**GEOTECHNICAL ENGINEERING  
REPORT ADDENDUM**  
Buttenwieser/Wiley Residence  
6838 96th Avenue SE  
Mercer Island, Washington

Project No. 200631 • April 26, 2022 (Revised August 16, 2022)

**City Comment Response  
Letter No. 2 (July 20, 2022)**

**Re: Geotechnical Comment Responses**

FIGURE NO.  
**1**

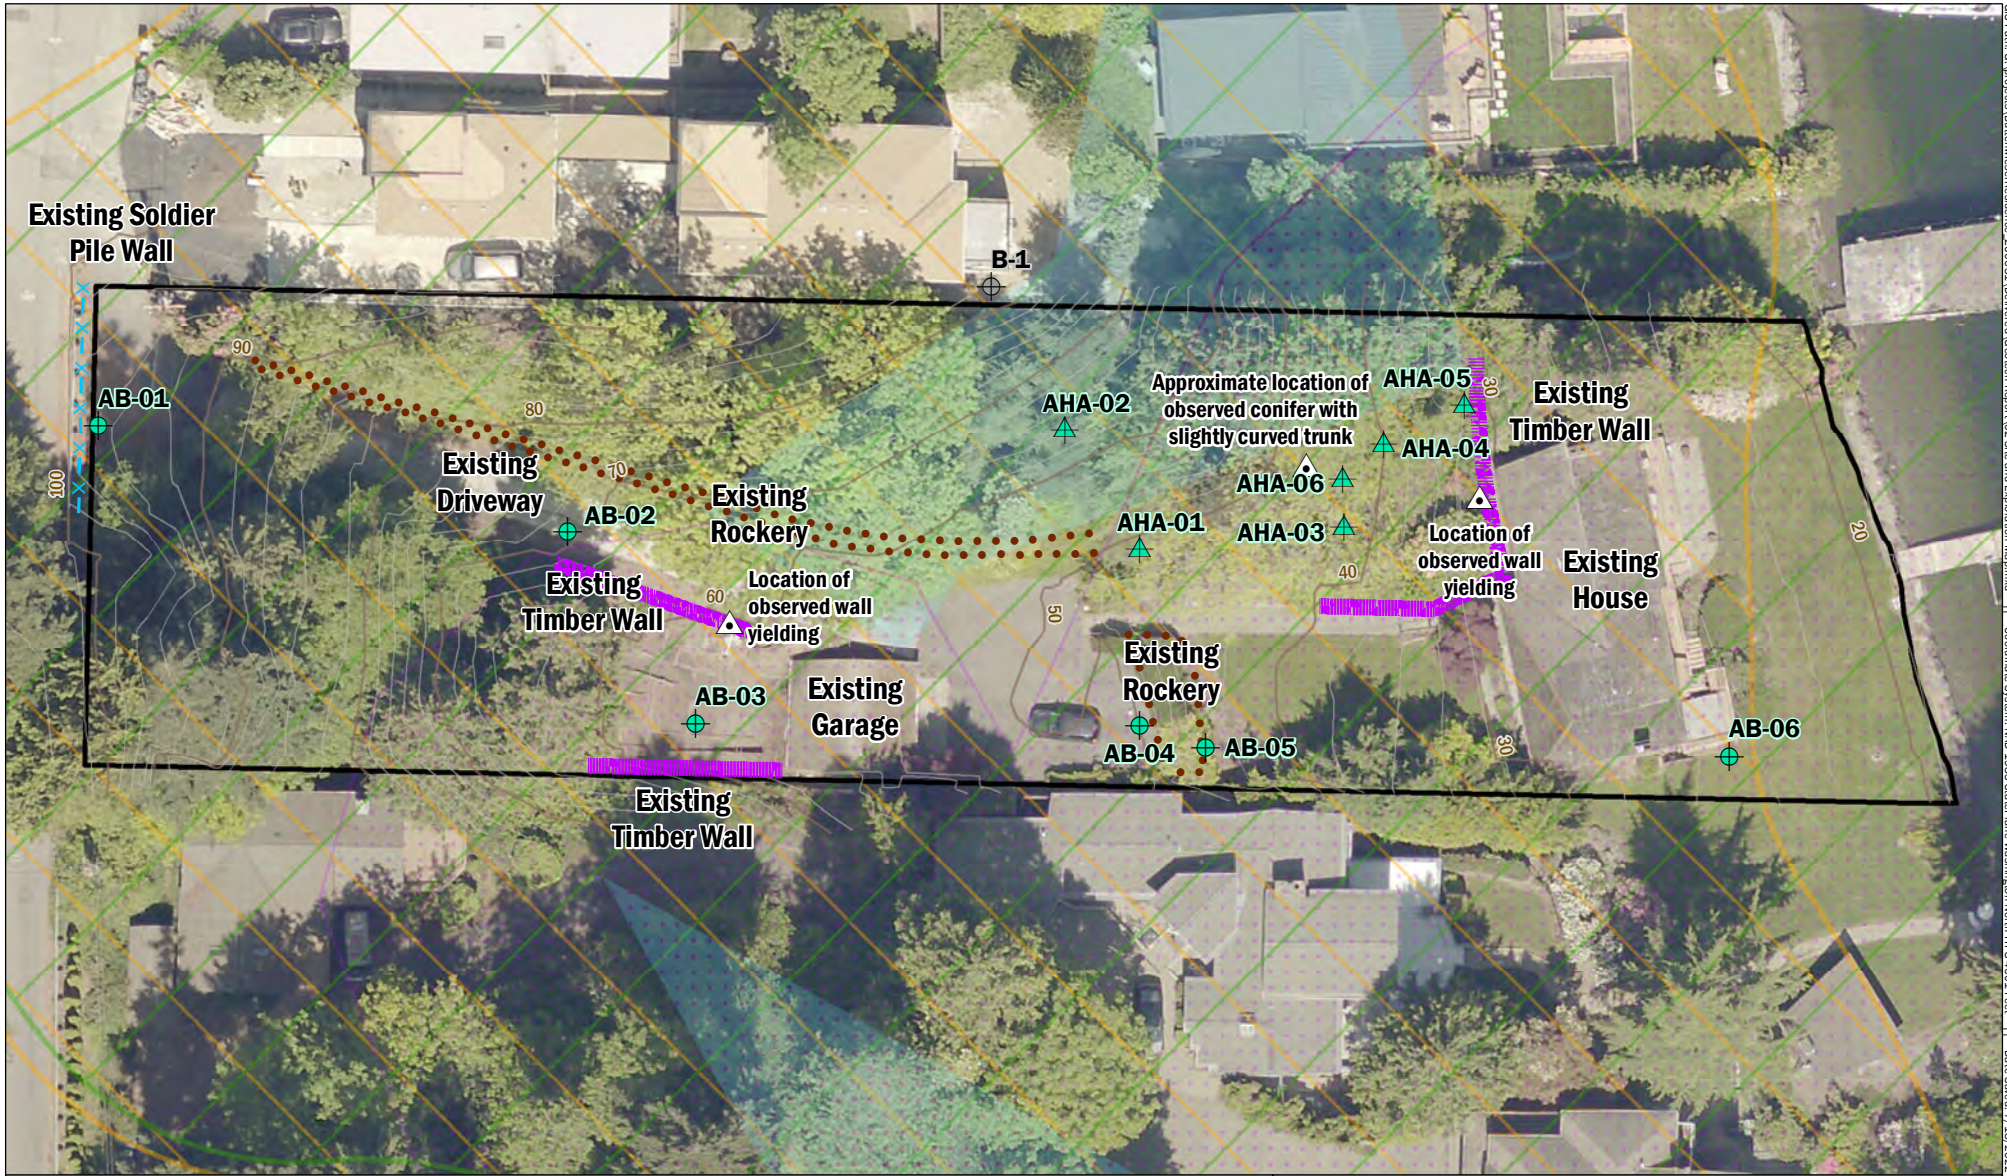
1. *Identify the locations, extents, and magnitudes of yielding conditions of existing retaining walls on a site plan. Include the location of the tree exhibiting response to slope creep discussed in geotechnical report section 2.1.3 on the site plan.*

2. *Specifically for the yielding retaining wall located northwest of the existing residential structure, indicate on a site plan, the location and extent of tension cracking in the soil or ground subsidence that is associated with this yielding condition. Indicate the cause of the yielding and whether the cause extends upslope.*

Our original geotechnical engineering report describes locations where existing retaining walls have yielded and where a tree trunk exhibits curvature. Refer to the Site Plan (Figure 1), which identifies these walls and trees and the extents of observed yielding.

**Aspect Response:** We have included the requested information in our addendum.

**Aspect Response:** We have included the requested information in our addendum.

FIGURE NO.  
**2**

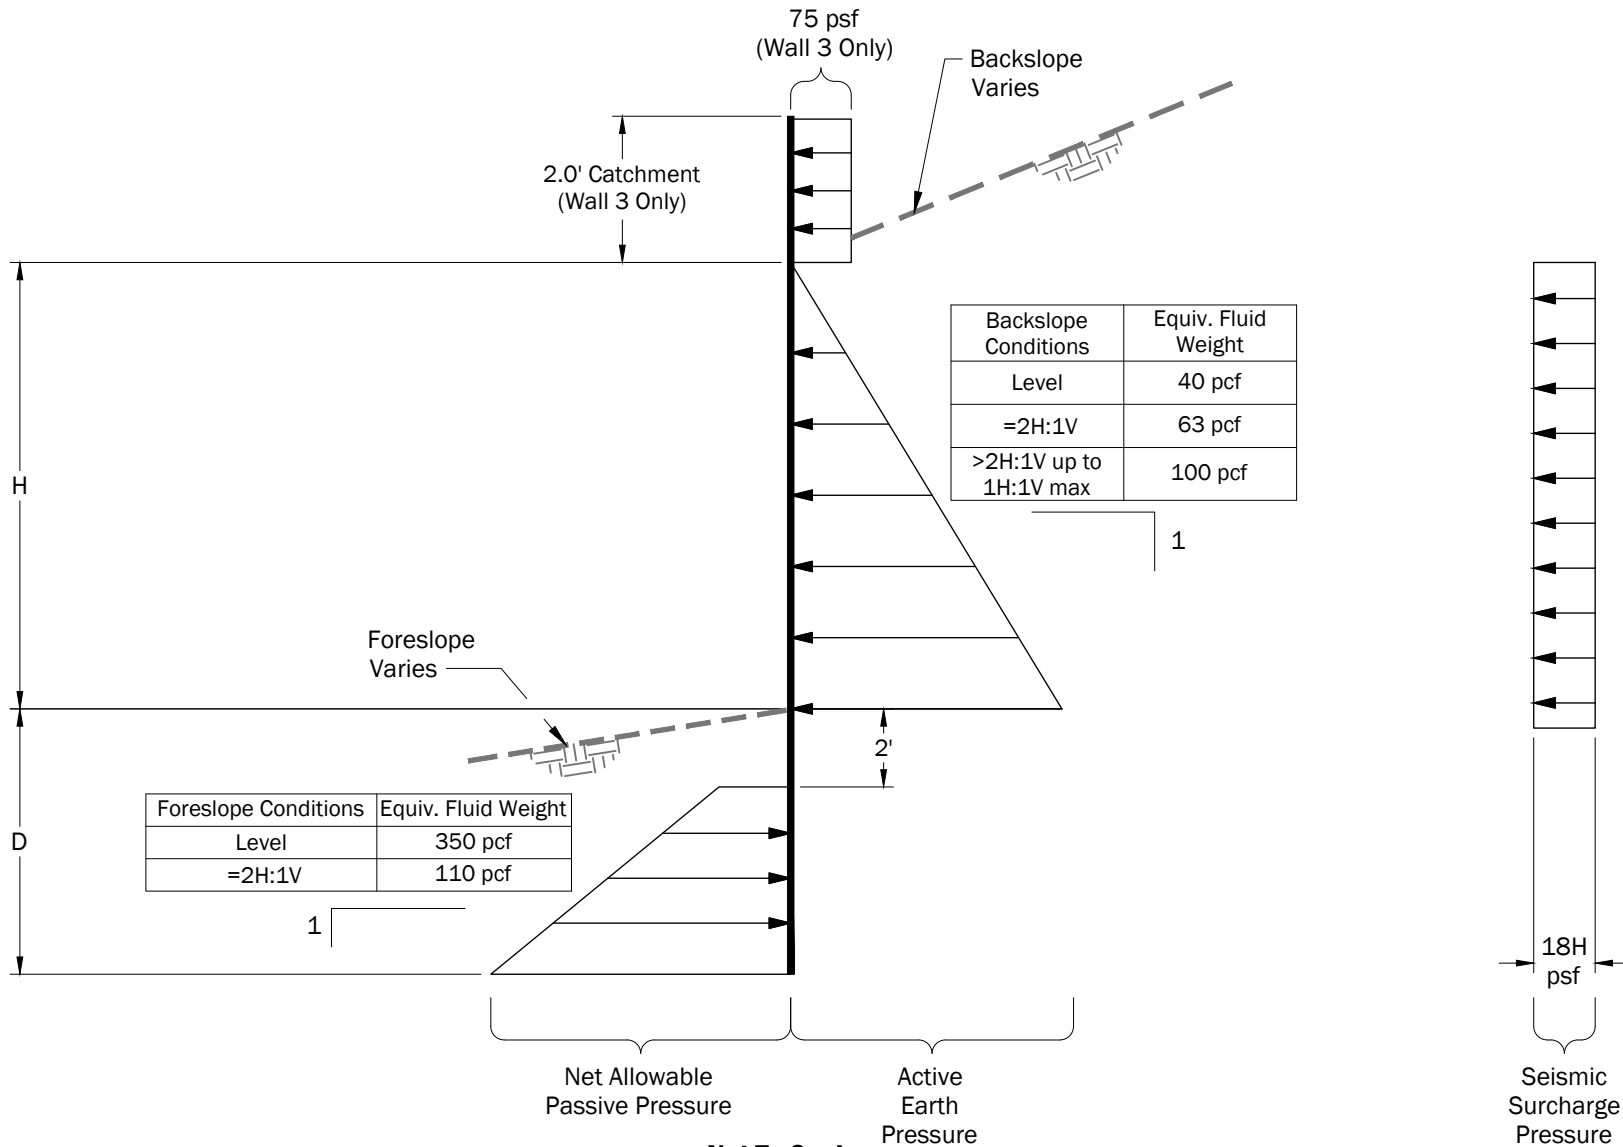
2. *“We also request documentation of assumptions and calculations to support the debris flow loading value and configuration.”*

6. *Based on existing topography, backslopes steeper than 2H:1V will be supported by some of the proposed site retaining walls. Geotechnical engineer to provide lateral earth pressures to be used in the design of these walls with steeper than 2H:1V backslopes.*

We included an earth pressure diagram for clarity as Figure 2 with this addendum.

In our experience, local professional practice has considered the various approaches used in the literature in combination with observational approaches. Practicing geotechnical engineers in the Puget Sound area have typically specified lateral debris loads on the order of 30\*H to 60\*H (in pounds per square foot), where H is the height of the wall. Based on our review of the literature and our local experience, it is our opinion that a uniform lateral load of 75 pounds per square foot, distributed uniformly over the stick-up height, is appropriate for use in design. This is presented graphically in the earth pressure diagram on Figure 2.

**Aspect Response:** Aspect has included a discussion of the assumptions and calculations supporting the debris flow loading value and configuration in the revised geotechnical addendum.

## Section C-C' Catchment Calculations

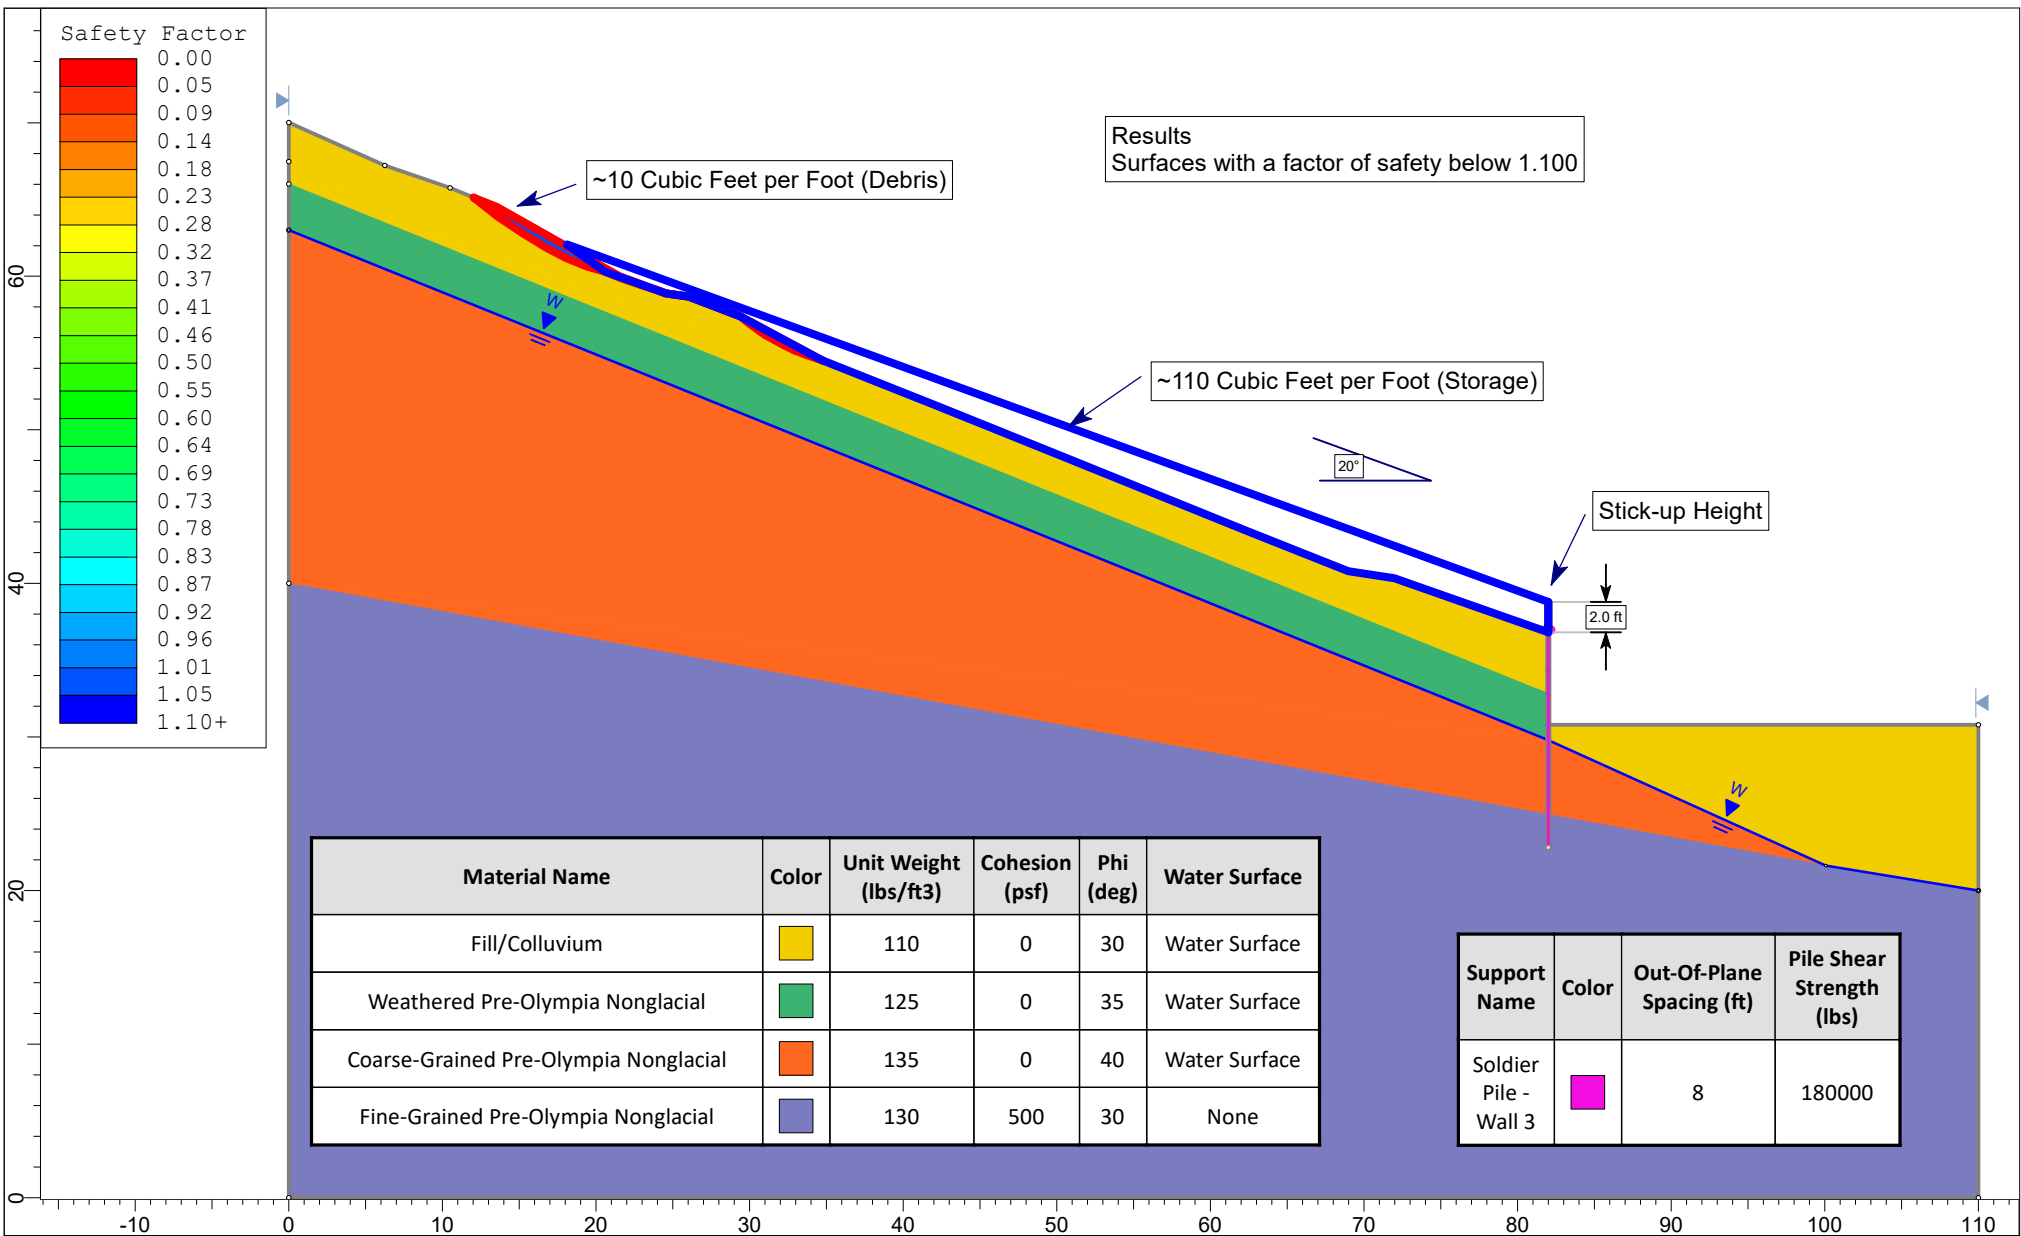
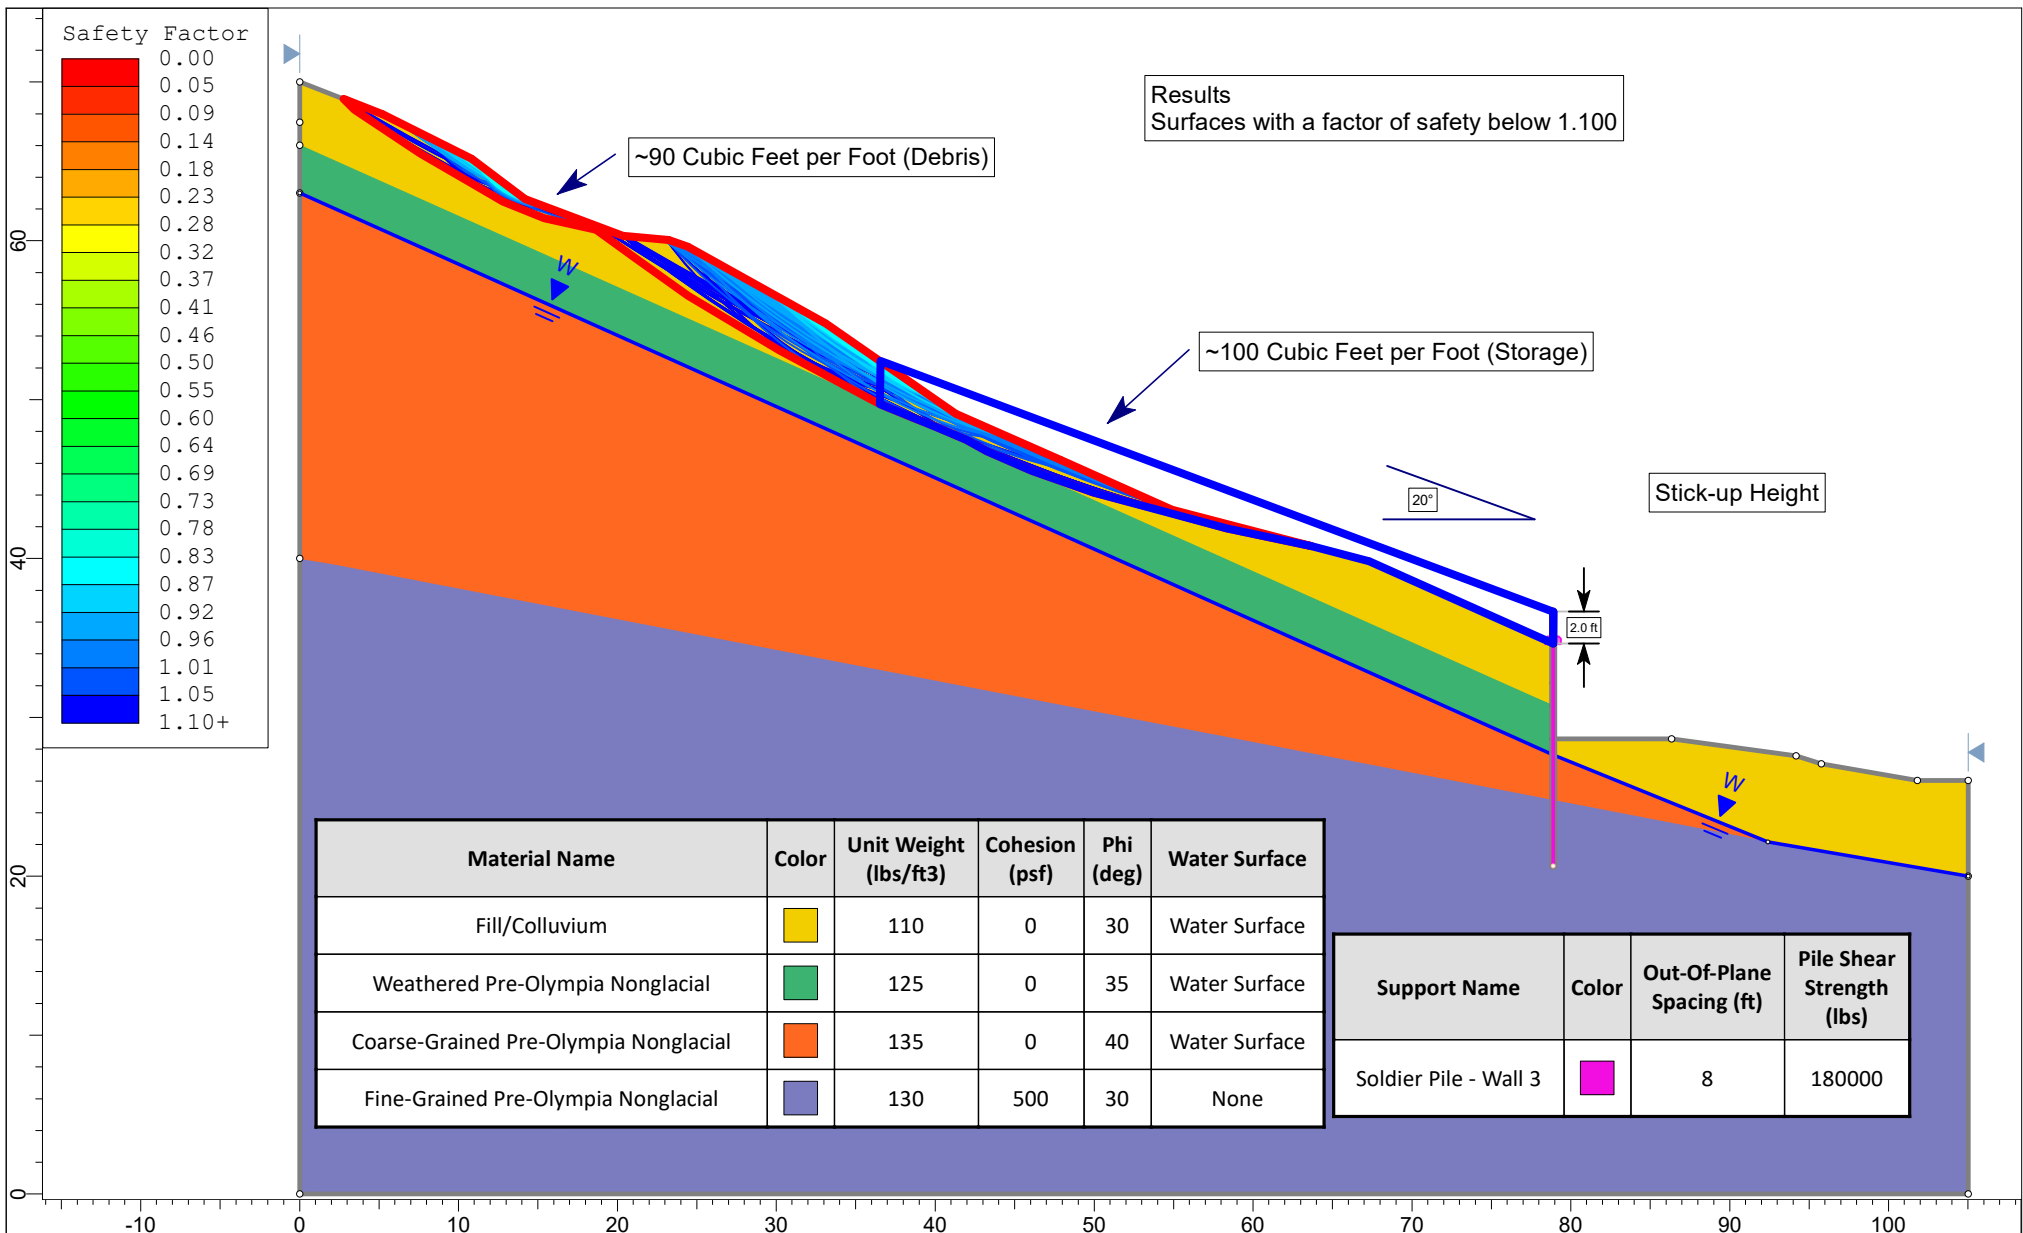
1. *“The geotechnical addendum addressed many of our review comments from the SUB1 review phase. The outstanding item remains the issue of catchment capacity and design of Aspect designated Wall 3. According to the geotechnical report addendum... .. the stratigraphy used in the slope stability cross-sections was not determined by specific borings or information at those specific cross-section locations... .. We recommend that the geotechnical engineer resolve the lack of subsurface information, revise cross-sections using the results from explorations located on the slope, revise slope stability analyses and catchment calculations.*

We performed stability analyses of the shallow landslide hazard to identify whether a catchment feature should be provided on the proposed soldier pile wall located at the base of the ECA steep slope north of the main residence (Wall 3). We analyzed sections C-C,' D-D,' and E-E' (refer to Appendices E and F) and found that section E-E' governed our catchment recommendations.

Based on our interpretation of the failure surfaces and ranges in calculated factors of safety, it is our opinion that a unit volume of slide debris expected to mobilize during a characteristic shallow slide is approximately 90 cubic feet per foot of slope width. Assuming the slide debris will come to rest at the base of the slope with a residual backslope of approximately 20 degrees, we recommend a minimum extra stick-up height for debris catchment of 2.0 feet above existing grade at the top back of the wall. These calculations are represented graphically in Appendix F.

**Aspect Response:** Aspect advanced a series of supplemental hand auger explorations on the slope to provide additional information regarding the thickness of the colluvium layer in cross-sections C-C’, D-D’, and E-E’. The supplemental exploration logs are included as an appendix to the revised geotechnical addendum. We revised the slope stability analyses and catchment calculations appropriately and included updated output results as appendices to the revised geotechnical addendum.
